2 **Evaluation of Subsurface Radionuclide Transport at**
3 **Commercial Nuclear Power Production Facilities**

4 ANSI/ANS-2.17 (Revised)

5 December 3, 2007

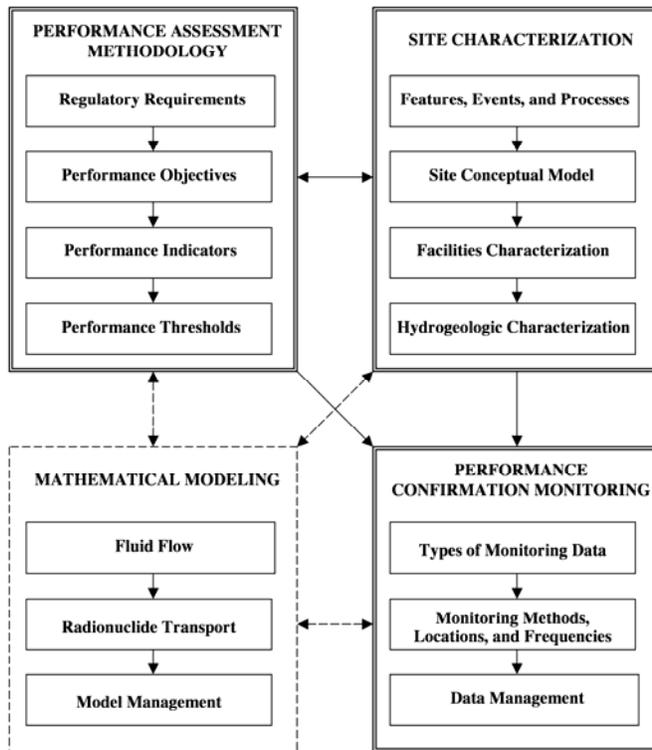
Comment [A12]: This figure should be referenced in the text. Also, it looks like boxes represent activities, and lines represent information flow or feedbacks.

Comment [A13]: Lines or boxes?

Comment [A14]: Since there is a two way link between the process blocks which is indicative of a repeating information flow, will it be possible to formulate an objective function from the performance objectives and optimize the process?
